Addendum No. 1
March 9, 2021

Project: Jane Addams Elementary School – C.I.P. Addition And Renovations PD #3312
Project location: 2511 W. Brookings Street, Sioux Falls, SD 57104
Project number: 1105.2914.20

Architect: Architecture Incorporated

2.81

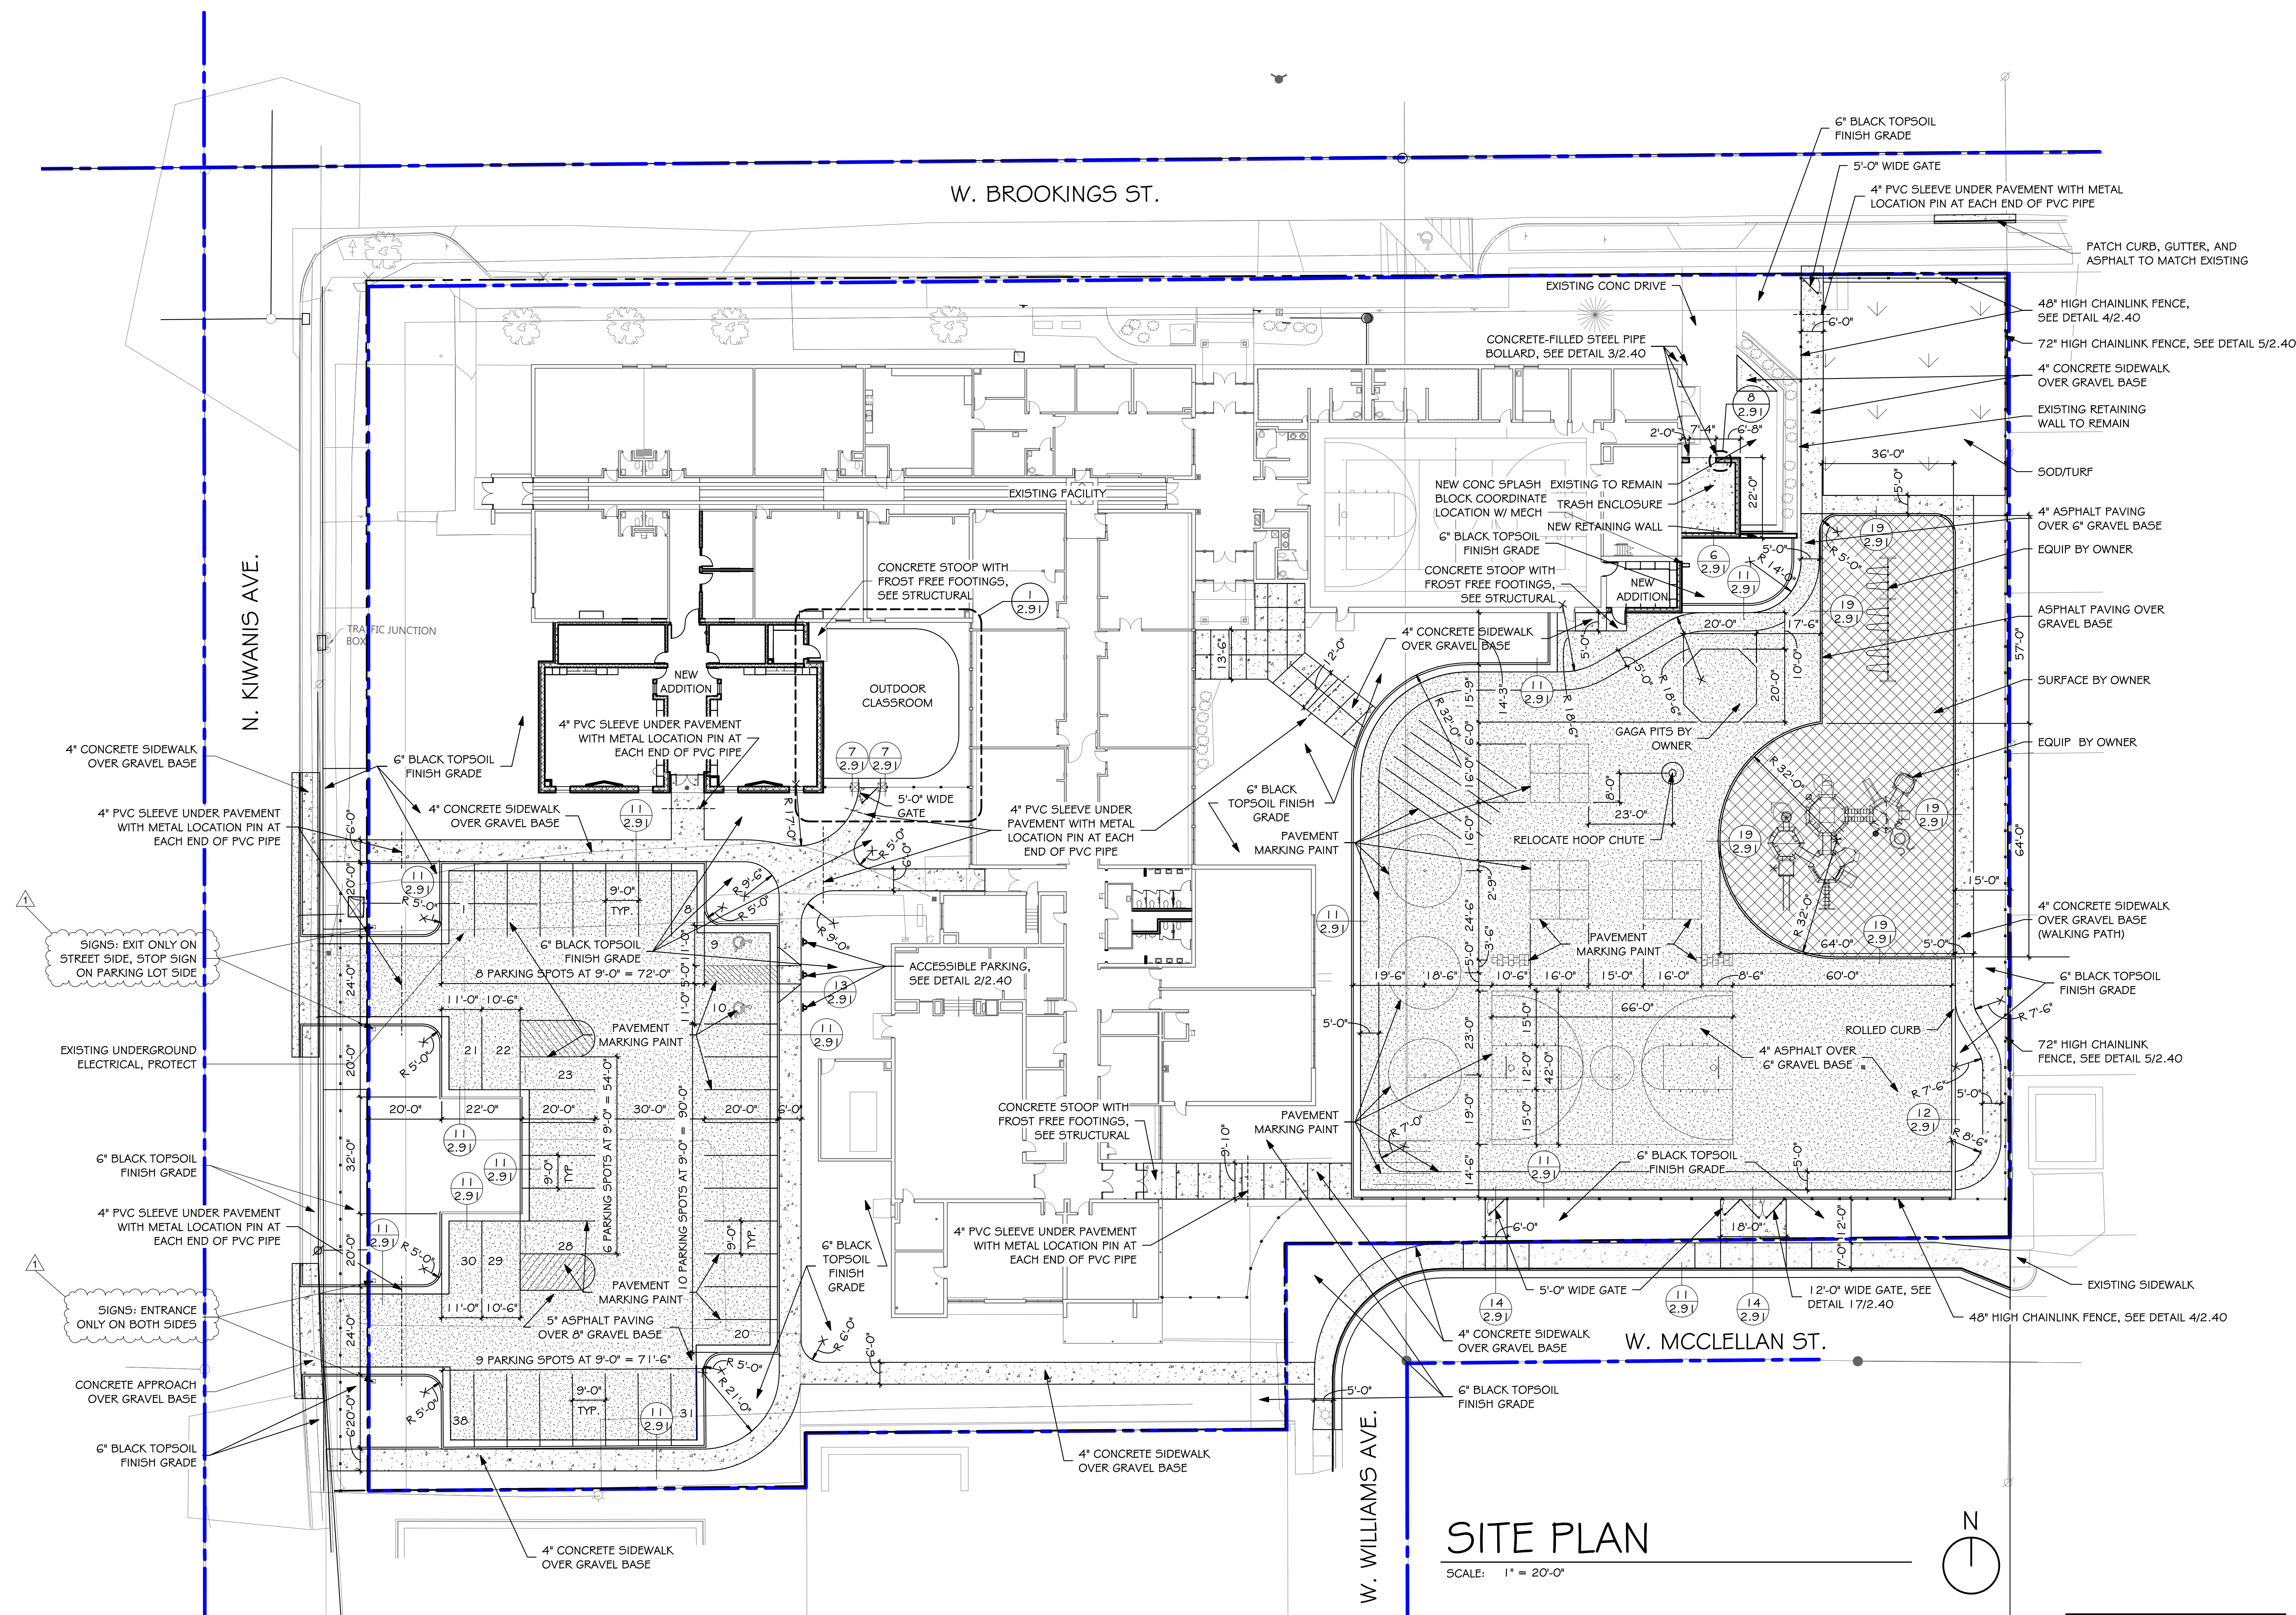
- b) Asbestos inside each of the 2 houses being removed will be removed by others and will be removed by April 1, 2021
- 10) DRAWING 2.81
- a) Site Plan:

- i) Furnish and install four (4) signs as shown on attached sheet 2.81. Two (2) signs shall say Entrance Only on both sides. Two (2) signs shall say Exit Only on street side and Stop sign on parking lot side.

- (1) **STOP** signs shall be 12" wide x 12" high; Background: RED; Border & Legend: SILVER; constructed from 0.080 inch (80 mil) reflective-coated aluminum.

(2) **Entrance Only** signs and **Exit Only** signs shall be 12" wide x 18" high; Background: WHITE; Border & Legend: BLACK; constructed from 0.080 inch (80 mil) reflective-coated aluminum

(3) Sign Posts: 2 lb/ft x 10' galvanized steel U-channel post.
